STATE OF MICHIGAN
DEPARTMENT OF ENVIRONMENTAL QUALITY
LANSING

August 20, 2009

SUBJECT: G&H Landfill Superfund Site, Review of January – July 2008 Report

Chart 15: G&H Landfill Superfund Site, Utica, MI
Leachate Elevation Inside Slurry Wall at GH-80

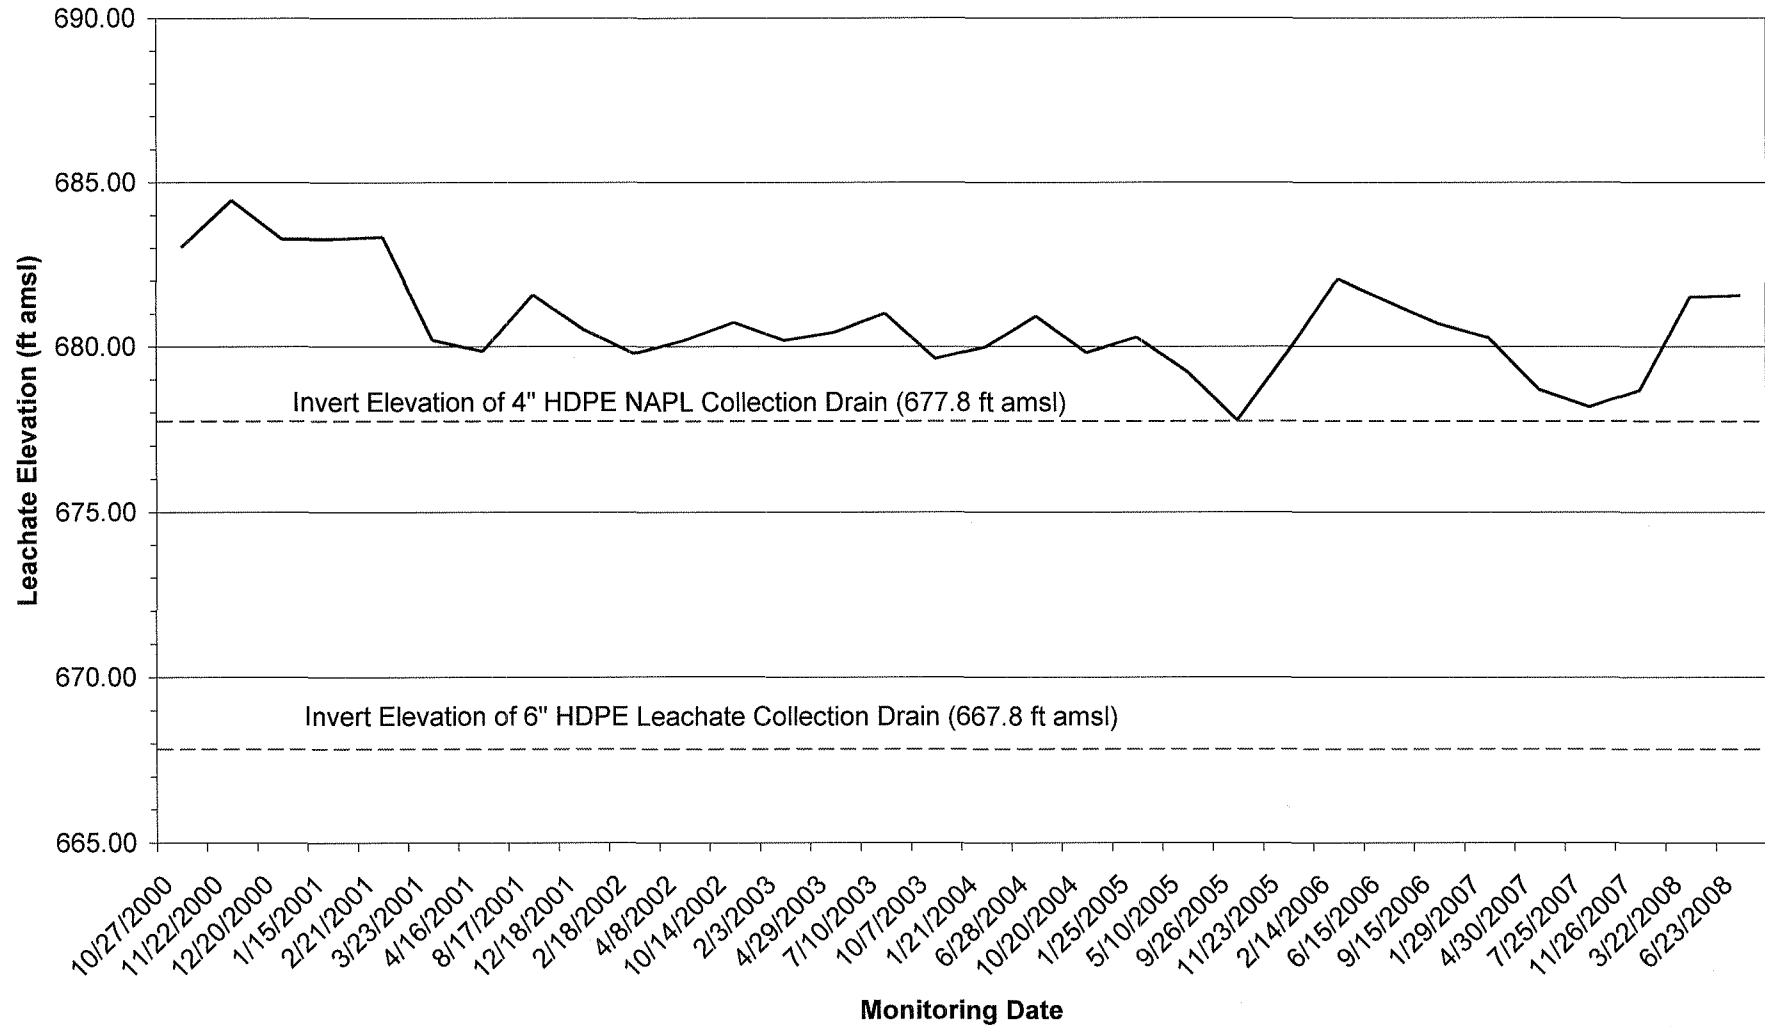
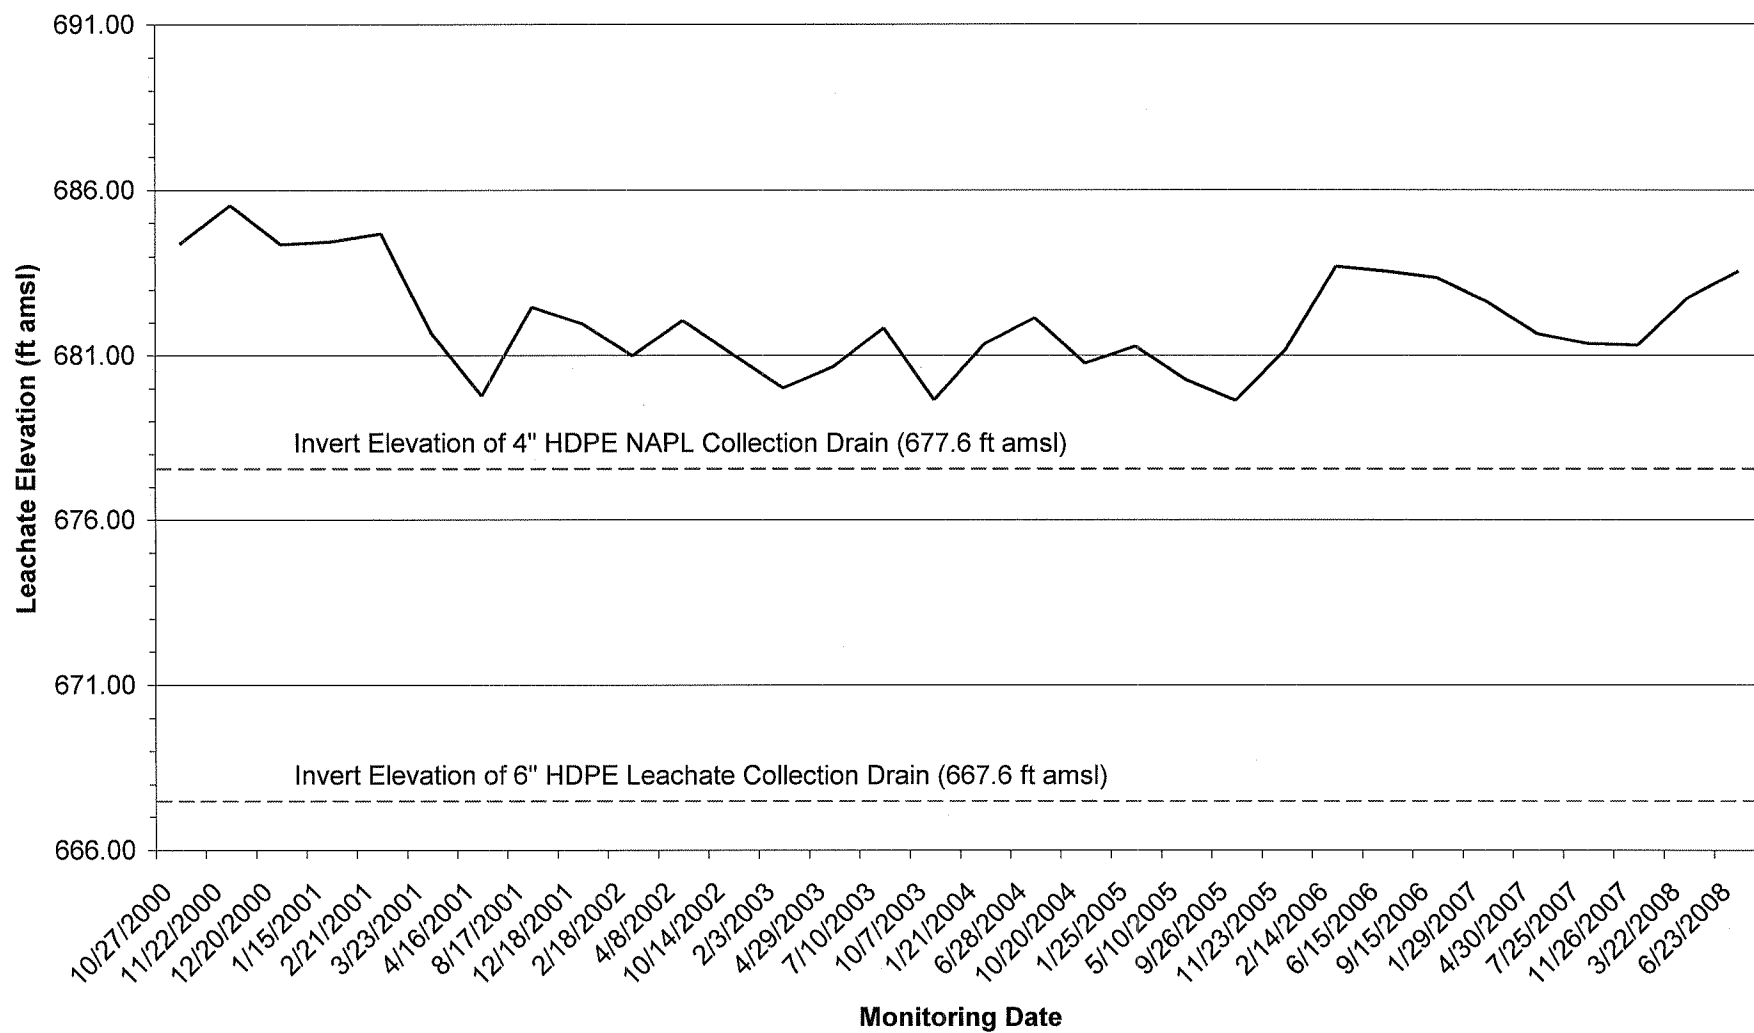
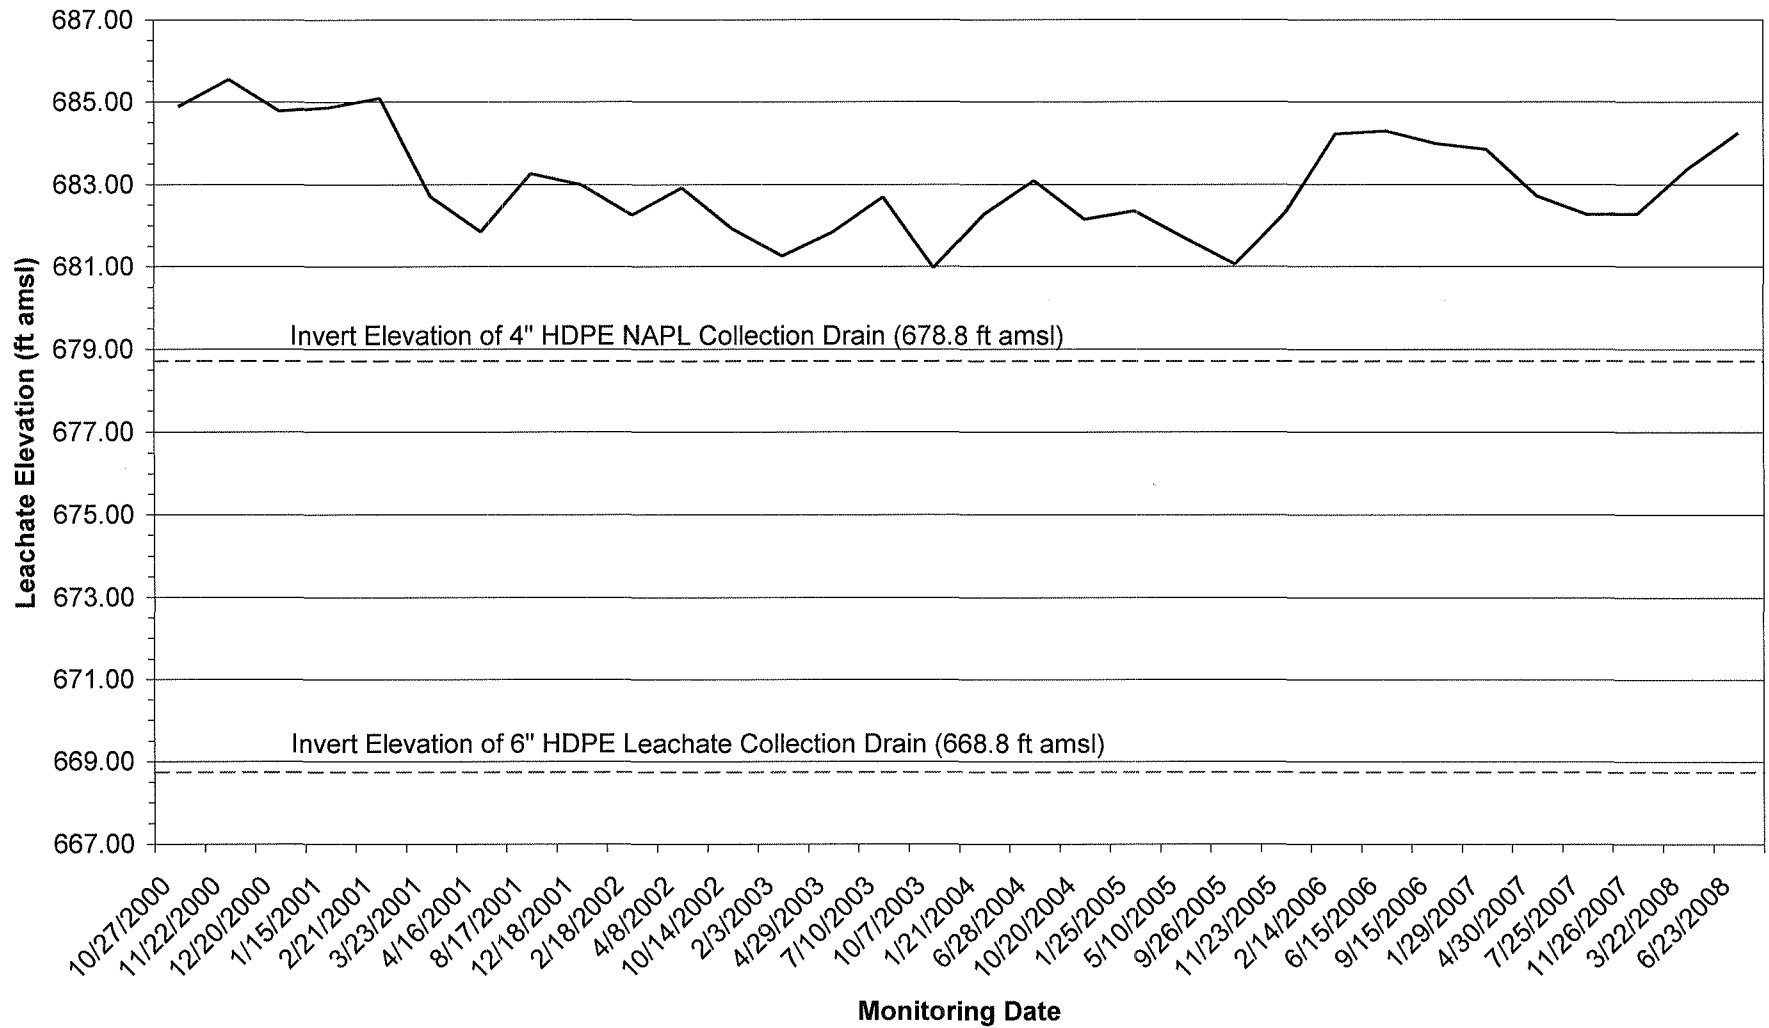
CRA reports water levels inside the barrier wall have remained stable. Water level trend charts, prepared by the MDEQ, are attached (Attachment B, Charts 9 - 16) for monitoring wells GH-52, GH-54, GH-56, GH-58, GH-60, GH-78, GH-80, and GH-82. The charts show water levels over time compared to the collection pipe invert elevations of the barrier wall collection system. The barrier wall collection system consists of a 6-inch high-density polyethylene (HDPE) leachate collection pipe and a 4-inch HDPE pipe, constructed approximately 10 feet above the 6-inch leachate collection pipe, to collect non-aqueous phase liquids (NAPL). The following observations are illustrated from the water level trend charts:

- Water levels have fluctuated approximately 2-3 feet seasonally within the capped cells with increasing trends observed at GH-52, GH-54, and GH-60 throughout the past 8 years of operation;
- Water levels have significantly exceeded the collection pipe inverts of the collection system throughout the past 8 years of operation;
- June 23, 2008, water levels at monitoring wells inside of the slurry wall range from 11.5 feet at GH-5 to nearly 16 feet at GH-80 above the invert¹ of the 6-inch HDPE leachate collection pipe; and
- June 23, 2008, water levels ranged from 3.75 feet at GH-78 to over 6 feet at GH-60 above the invert of the 4-inch HDPE NAPL collection pipe.

In summary, hydraulic and chemical data reviewed in this report do not present successful performance of the barrier wall and collection system at many monitoring locations. Additionally, the water level observed above the NAPL collection piping eliminates the ability of the collection system to retrieve NAPL.

- Implement the approved corrective action plan to achieve hydraulic and physical containment of the source areas;
- Execute contingency plans to achieve the 2-feet inward gradient at the barrier wall and maintain water levels to allow the collection of NAPL from the Phase I and Phase II landfill cells as required in the SOW;

Chart 18: G&H Landfill Superfund Site, Utica, MI
Leachate Elevation Phase III Toe Drain at GH-48 and GH-49

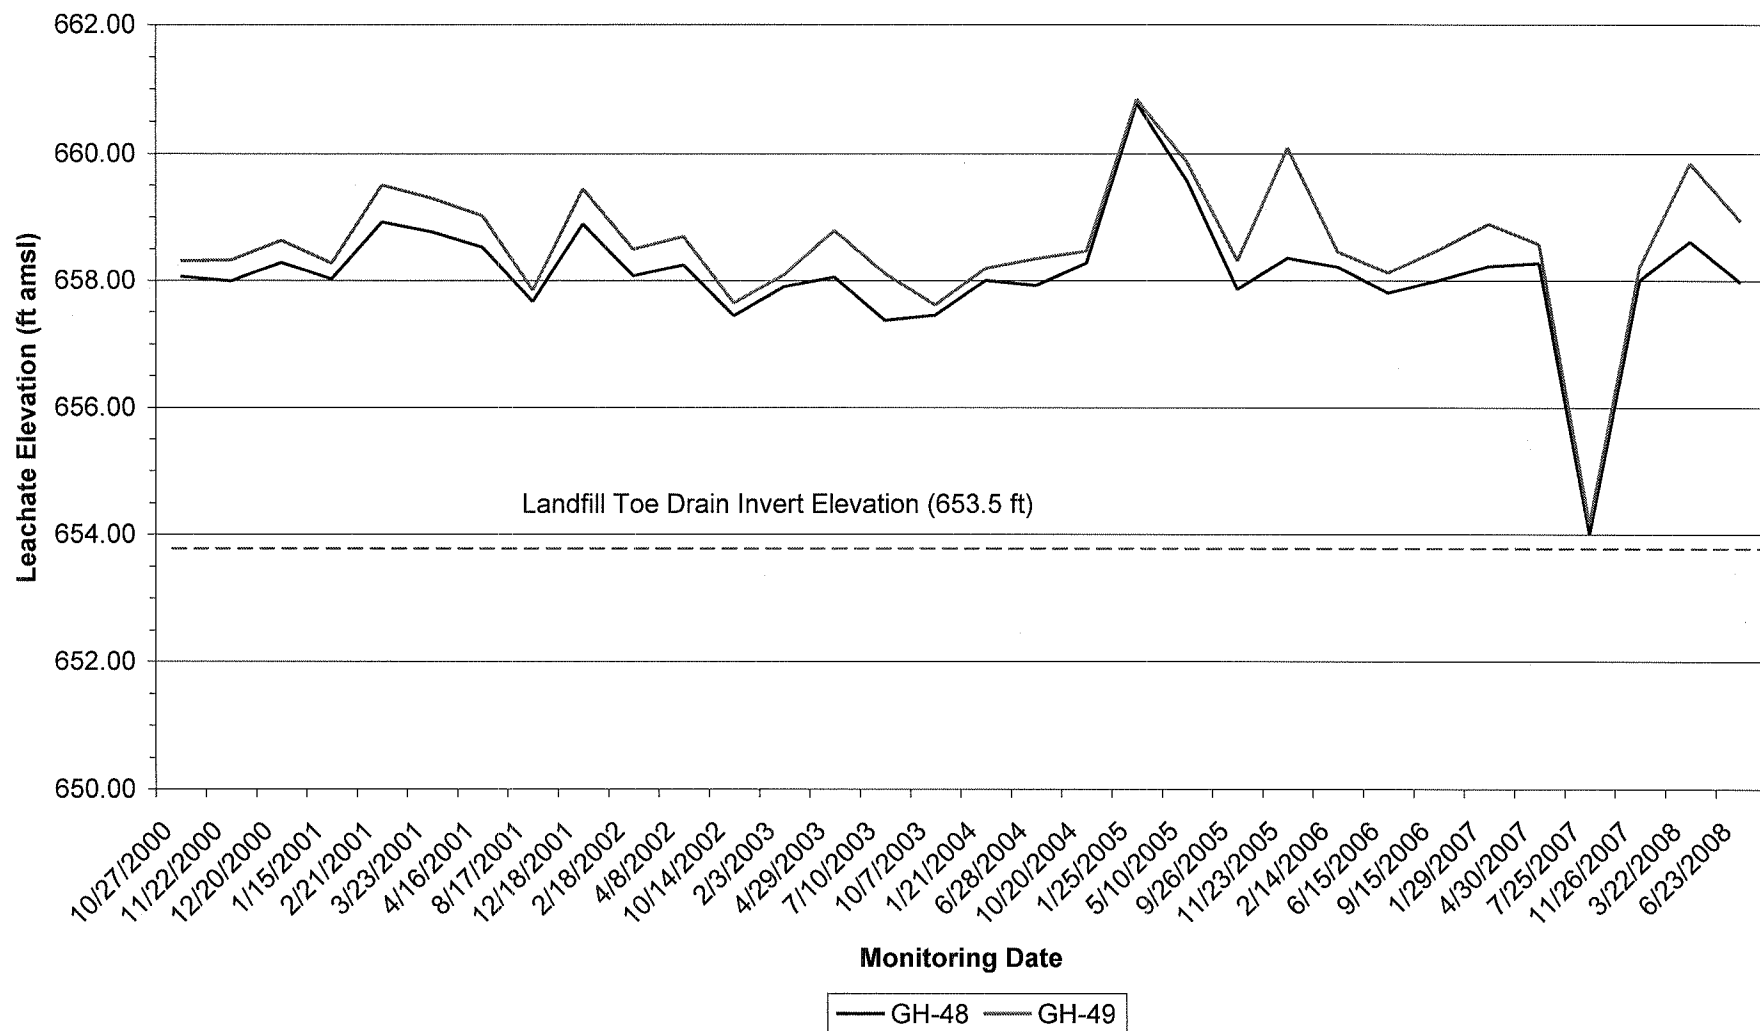
The OMP indicates that the pipe and media drain located along the west side of Phase III is designed to dewater the Phase III slope and intercept groundwater/leachate to prevent off-site migration. Additionally, the OMP indicates the pipe and media drain will be operated to maintain a dewatered condition. The MDEQ evaluated the water levels measured at GH-48, GH-49, and GW-10 over time with the toe drain collection pipe invert¹ elevation of the 6-inch HDPE collection pipe. The following is shown on Charts 18 and 19 (Attachment B):

- Water levels have significantly exceeded the toe drain collection pipe invert of the collection system throughout the past 8 years of operation; and
- June 23, 2008, water levels ranged from 4.27 feet at GW-10 to 5.44 feet at GH-49 above the toe drain collection pipe invert.

As indicated from Charts 18 and 19, the Phase III collection system has not achieved the performance objective of a dewatered condition and likely is not providing hydraulic containment of the leachate and contaminated groundwater migrating from Phase III.

- Evaluate the performance of the Phase III leachate collection system and execute contingency plans to achieve hydraulic containment at the Phase III landfill toe as required in the SOW;
